RESOLUTION NO. 735

A RESOLUTION RELATING TO SUBDIVISIONS AND APPROVING THE PRELIMINARY PLAT AS REFLECTED IN THE PLANNING COMMISSION RECOMMENDATION FOR THE WOODLAND CREEK PLANNED UNIT RESIDENTIAL DEVELOPMENT ("PURD"), SUBJECT TO CERTAIN PROVISIONS AND CONDITIONS MORE PARTICULARLY DESCRIBED HEREIN.

Agenda Item: Review and approval with conditions of the Woodland Creek PURD 150-lot subdivision (PUD-20-001) as recommended by the Woodland Planning Commission.

**Project Title: Woodland Creek Planned Unit Residential Development
 Subdivision (150-lot Subdivision)**

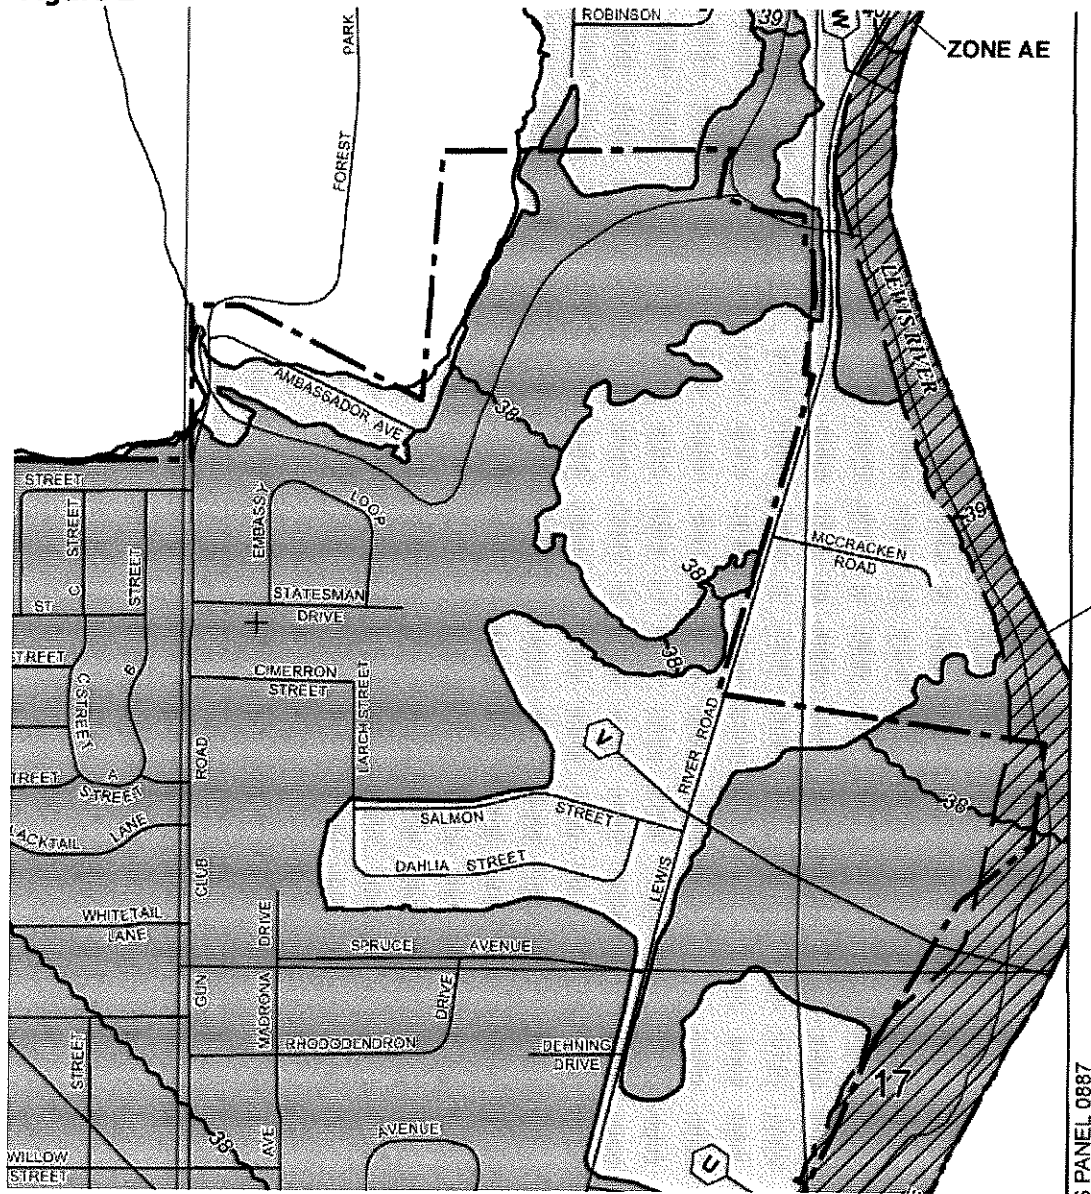
Finding 34: The applicant is required to design and install a stormwater system as required by local, state and federal standards. These improvements are designed, reviewed, installed and inspected by qualified professionals. Compliance with these standards meets the city's expectation for new development.

Finding 35: Public comments received by staff and taken at the neighborhood meeting indicates that neighbors are concerned about existing drainage conditions upstream of this development. Staff notes that the applicant is not obligated to resolve existing drainage issues that may exist independent of their project.
